Enclosure I to ET 18-0012

Attachment 1 to SAP-18-34, "Supplemental 30 Day Responses to Nuclear Regulatory Commission Request for Additional Information Regarding Wolf Creek Generating Station Transition to Westinghouse Safety Analysis and Alternate Source Term Methodologies"
Non-Proprietary

**Supplemental 30 Day Responses to Nuclear Regulatory Commission
Request for Additional Information Regarding Wolf Creek Generating
Station Transition to Westinghouse Safety Analysis and Alternate
Source Term Methodologies [Non-Proprietary]**

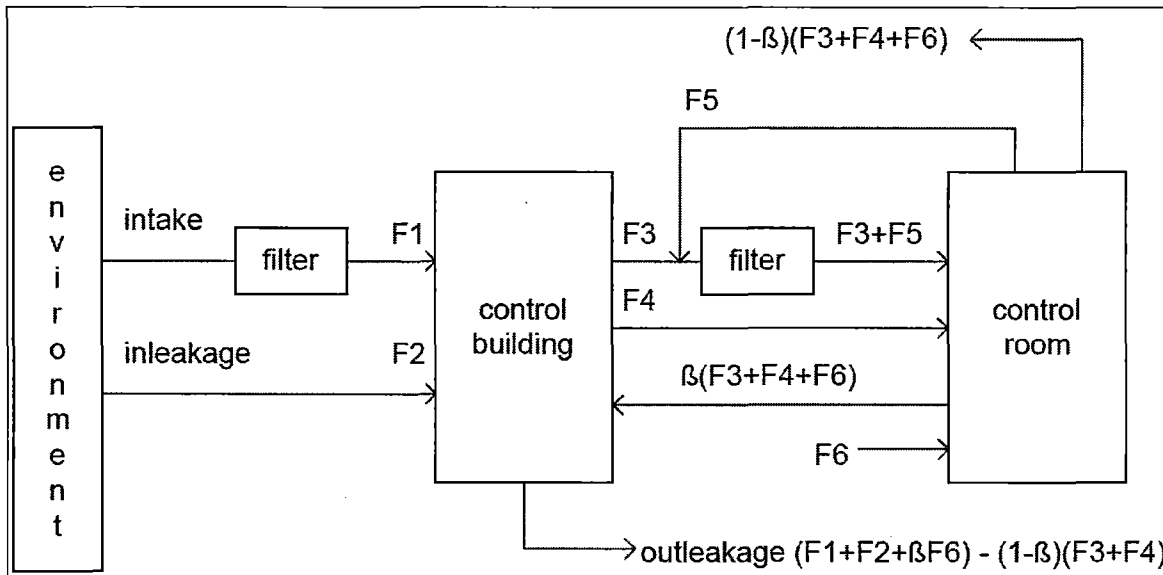
As a result of the audit conducted on March 19 and 20, 2018 at the Westinghouse Rockville, MD office, additional discussion is provided for the SGTR scenario when considering a loss of offsite power at the start of the event; the additional discussion is related to the modeling of the control room, and includes a summary of the control room modeling assumptions. For completeness, the other events are also included in the summary of control room modeling assumptions.

With respect to the SGTR, a loss of offsite power at the start of the event would not significantly affect the plant response, only the timing. The major dose contributors, such as post-trip flashed break flow, total break flow and post-trip ruptured SG releases are driven by decay heat removal and so would be unaffected. Essentially, the sequence of events with respect to the releases would shift by approximately

52 seconds (0.014 hours); these 52 seconds are also within the conservatism added to the start of emergency mode filtration and normal HVAC intake damper closure. Removing the first 52 seconds of releases from the model and removing added conservatism to the control room emergency mode actuation and normal HVAC intake damper closure would result in a slight decrease in calculated dose.
